**REMARKS**

ANNOTATED SHEET SHOWING CHANGES

FIG. 3

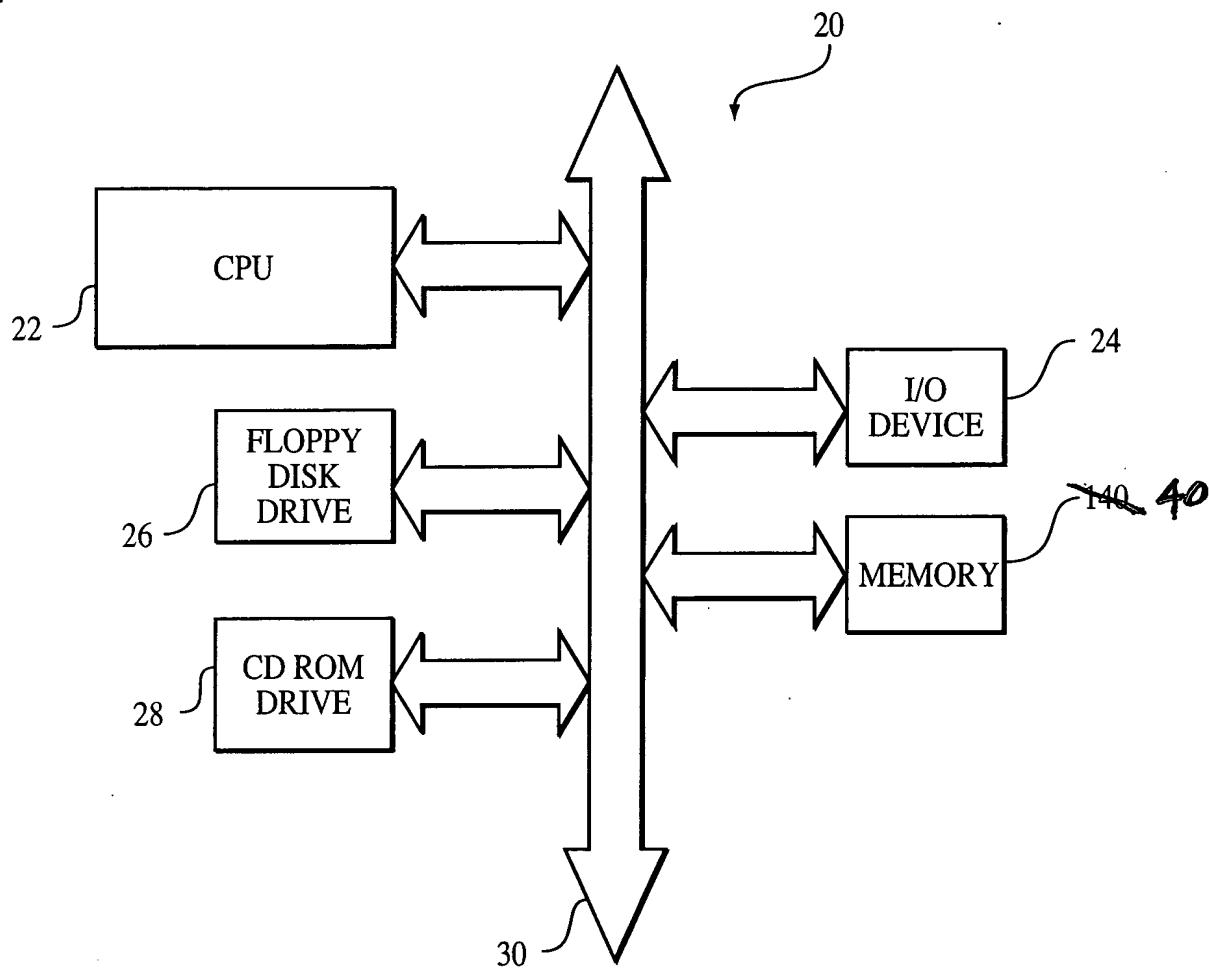
FIG. 3 has been amended to change the reference numeral "140" to "40."

The drawings are objected to for failing to comply with 37 CFR § 1.84(p)(4) because the reference numeral "140" is used in FIGS. 1 and 3 to designate two different elements. FIG. 3 has been amended to correct this informality. Therefore, withdrawal of this objection is respectfully requested.

The drawings are further objected to for failing to comply with 37 CFR § 1.84(p)(5) as the reference numerals of FIG. 3 are not mentioned in the description. The specification is also objected to for lacking a detailed description of FIG. 3. The specification has been amended to include a detailed description of amended FIG. 3

and to describe the reference numerals shown in amended FIG. 3. Therefore, withdrawal of this objection is respectfully requested.
